INVITATION TO TENDER "ITT" NO. PS20181181  
CONSTRUCTION SERVICES FOR THE GRANVILLE BRIDGE STRUCTURAL REPAIR

QUESTIONS AND ANSWERS NO. 2

ISSUED ON SEPTEMBER 4, 2018

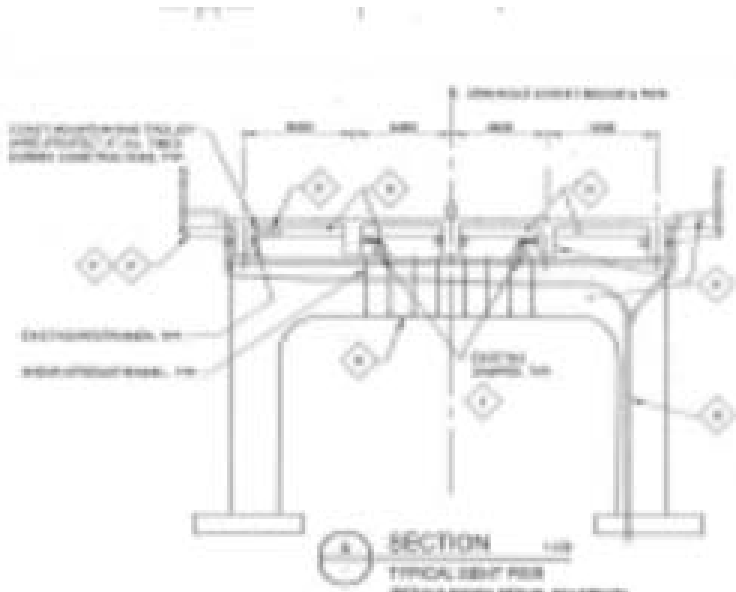
Q3	<p>Is there a payment item for "J"?</p> <p><u>NOTES:</u></p> <p>1. FOR GENERAL NOTES-SEE DIVS. 2125-101 &amp; 102.</p> <p><u>WORK DESCRIPTION:</u></p> <ul style="list-style-type: none"> <li>A EXPANSION BEARING REPLACEMENT</li> <li>B BEARING CORROSION REMOVAL AND CLEANING</li> <li>C CONCRETE REPAIRS</li> <li>D DIAPHRAGM RESTORATION</li> <li>E LAMP STANDARD CORROSION REMOVAL AND COATING</li> <li>F LAMP STANDARD REPAIRS</li> <li>G DRAIN PIPE REPAIRS</li> <li>H COAT UNDERSIDE OF FIER CAPS</li> <li>J DAMPER GROUT PAD REPAIRS</li> <li>K BUS FEEDER CABLE SHIELDING</li> </ul>
A3	A payment item was added in Addendum 1.
Q4	Is there a payment clause for replacement of corroded reinforcement?
A4	There is no payment item for corroded reinforcement. If corroded reinforcement is encountered, this will be paid for as per GC.47 of the contract.
Q5	What City permits are required?
A5	It is the responsibility of the contractor to identify and obtain any required permits to complete the work. The permits will depend on proposed methodology and schedule.
